Sales Selection Sheet

Wallaceton

PURCHASER: INVENTORY HOME 188A-1

UK-75 WALLACETON LOT 188A-1 20-2146 CRN ELEV B THE UPTON

OVALYNTM UNDERCOUNTER SINK **VITREOUS CHINA**

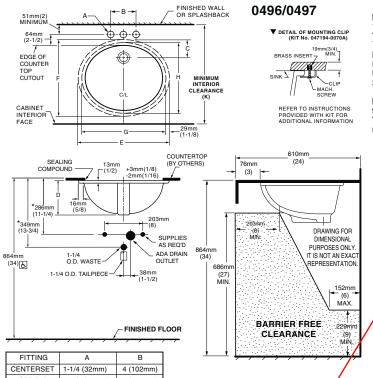
2 CHANGE DOUBLE STD COLONY SINKS TO DOUBLE UNDERMOUNT OVALYN SINKS FOR QUARTZ COUNTERTOP

Counter was produced with dropin sinks, to leave as is as per Marilyn -Jan 11, 2021.
